REQUEST FOR PROPOSALS
ANC 21-06C
Anchorage Pioneer Home Resident Renovations

ADDENDUM NO. 3

ANCHORAGE PIONEER HOME
ANC 21-06C RESIDENT RENOVATIONS

SK-01

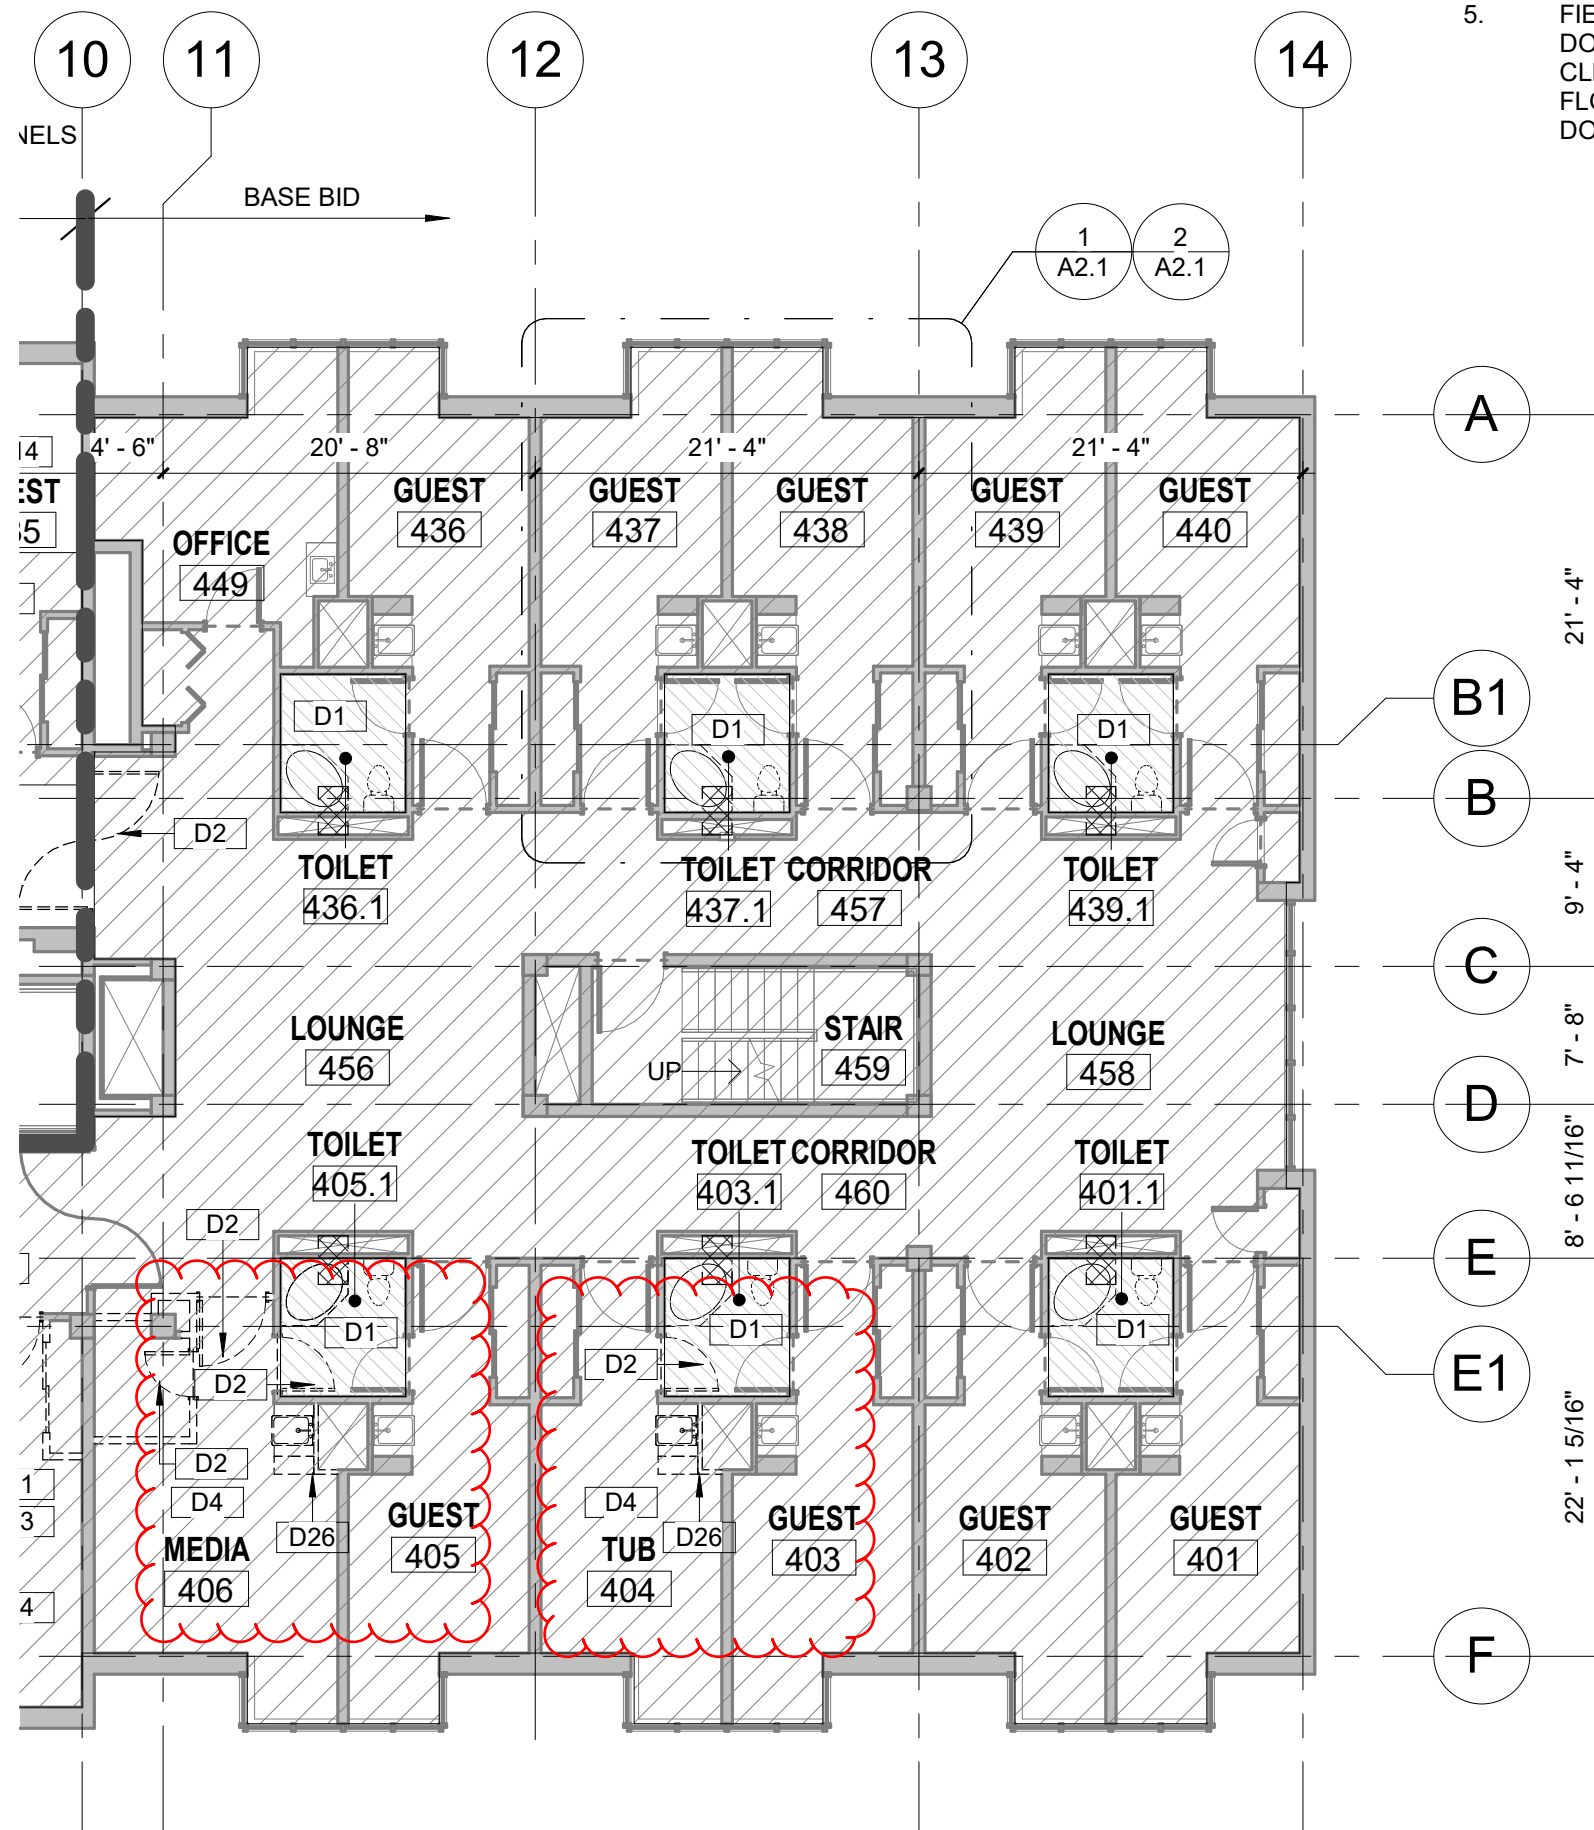
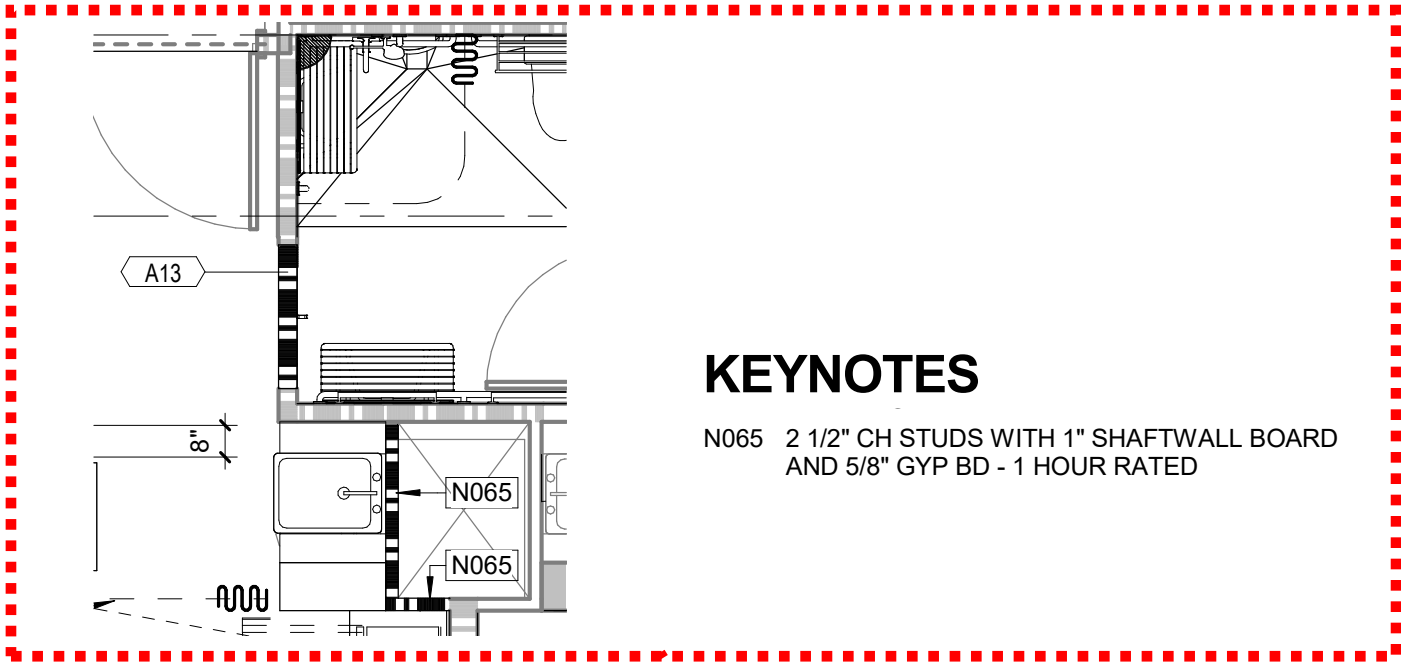
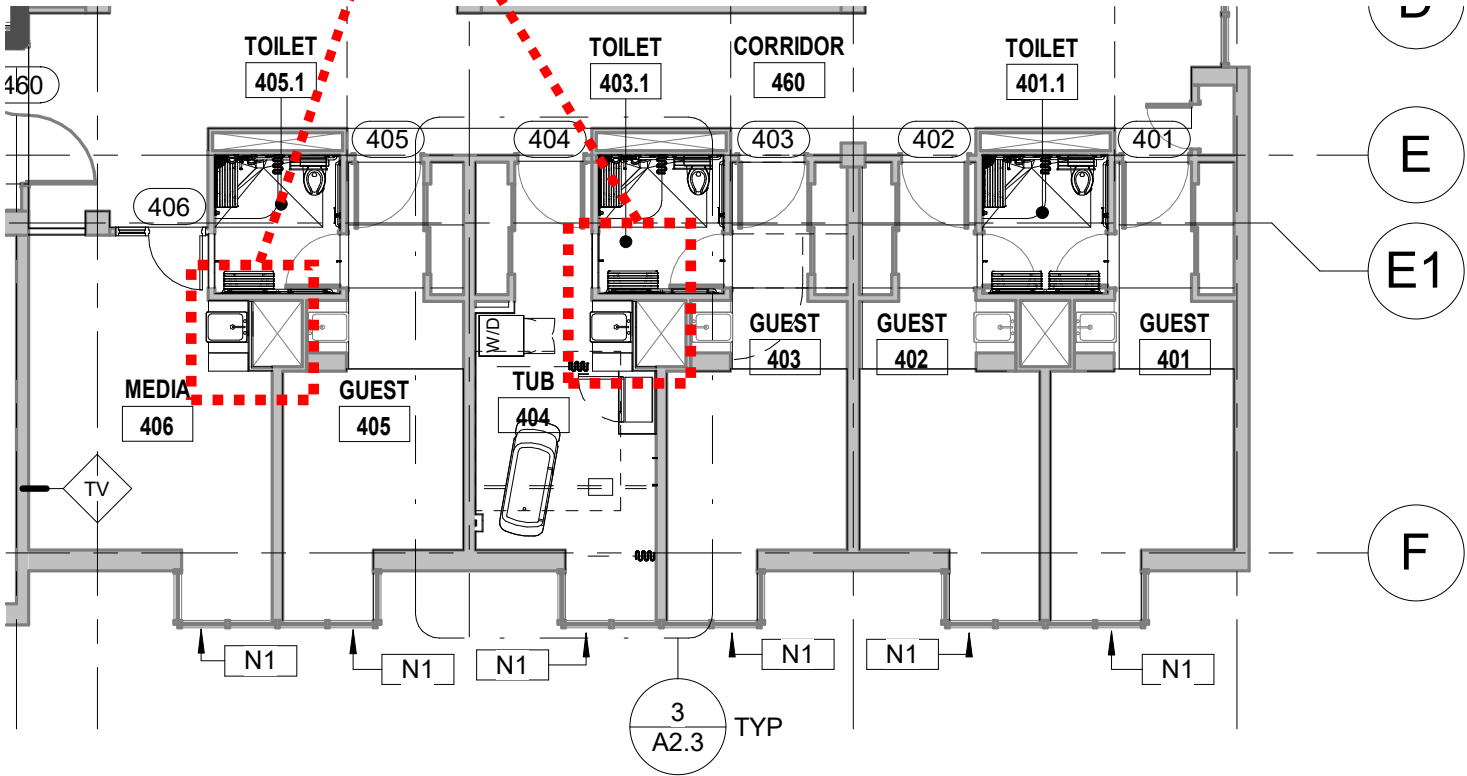
Question 1. Mechanical shafts walls currently have ½-inch drywall and non-CH type studs which does not meet the required 1-hour rating. Is it your intent to re-work all mechanical shafts on the 4th floor to meet the depicted required 1-hr rating as per design?

Response: The gypsum wall enclosures between each of the bedrooms and bathrooms are not shafts and do not require 1 hour fire protection. This question did cause us to re-evaluate the fire protection between the non-sleeping rooms and sleeping rooms where a toilet room is located. One hour protection is required between a sleeping room and a non-sleeping room. There are two rooms of concern, the Tub Room, and the Media Room. Each of these rooms has a door way that is to be infilled. That infill and the surrounding GWB is to be constructed as a 1 hour partition. The wall on the left side of the lavatory/vanity where it intersects with the new 1 hour wall is required to be 1 hour protected. This protection is also needed where the wall passes behind the lavatory and then closes against the wall separating the Tub Room from the residential room in one case and the Media Room and a residential room in the other case. This partition is to be constructed of CH style studs with 1 hour fire protection. Existing lavatories/vanities are to be reinstalled on the new fire separation partition. See sketch.

- D25 COMPLETE DEMOLITION OF CARPET AND BASE - CLEAN AND PREPARE FLOOR FOR NEW FLOORING
- D26 REMOVE EXISTING CASEWORK AND SINK (LAVATORIES/VANITIES) AS REQUIRED TO INSTALL NEW 1 HOUR SHAFTWALL. REINSTALL CASEWORK AND SINK AS INDICATED

N065 2 1/2" CH STUDS WITH 1" SHAFTWALL BOARD
AND 5/8" GYP BD - 1 HOUR RATED
